ZENITH RADIO CORP.

MODELS 210-5, 211-5, 270-5
Schematic

Zenith 210-5, 211-5, 270-5, 510-5

Old and new oscillator circuits in the Zenith chassis 2046.

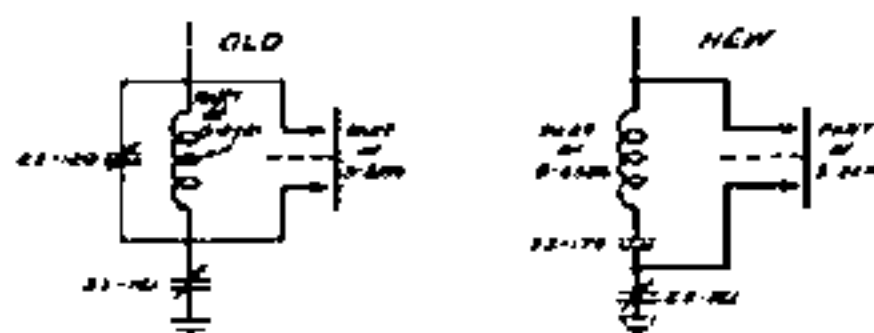
has been changed from Part No. S-2222 to Part No. S-2587. Condenser Part No. 22-137, listed on pages 3-1 and 2729 as having a value of 0.5 mf, should be listed as 0.05 mf; please make this change in your Manual. Also note the additional model, Model 510-5, using Chassis 2046.

Chassis 2046, used in Zenith Models 210-5, 211-5, 270-5 and 510-5, contains a few changes as compared with the schematic shown on page 3-1 of *Rider's Volume III* and on page 2729 of the *Rider-Combination Manual*. The only changes in the schematic are found in the oscillator circuit; the accompanying illustration shows these

changes, including both the early and more recent designs. Note that a new part has been added, Part No. 22-179, a series padder; Part No. 22-120 has been removed. In the more recent design, the oscillator coil has been changed from Part No. S-2221 to Part No. S-2586, and the preselector coil
